**Notice of Addendum**

**ADDENDUM #3  
Next Generation (NG) 9-1-1 Phone System  
Jefferson County, WI  
(1 Page Total)  
May 11, 2015**

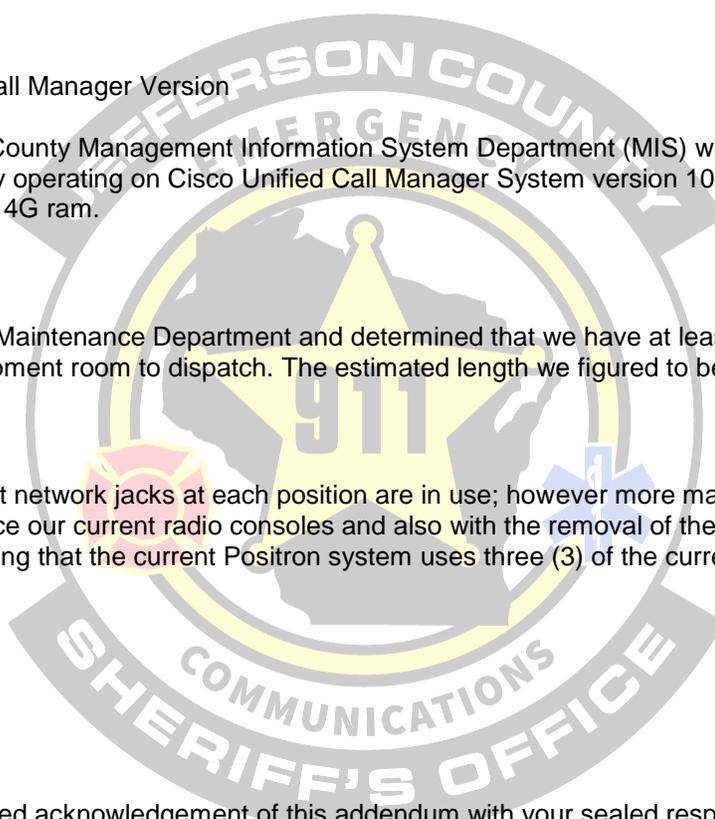
**Question #1:** Current Cisco Call Manager Version

**Answer #1:** According to our County Management Information System Department (MIS) which oversees the county phone system; we are currently operating on Cisco Unified Call Manager System version 10.5.2.10000-5; VMWare Install: 2 vCPU Xenon, 2.4GHz, 80 G, 4G ram.
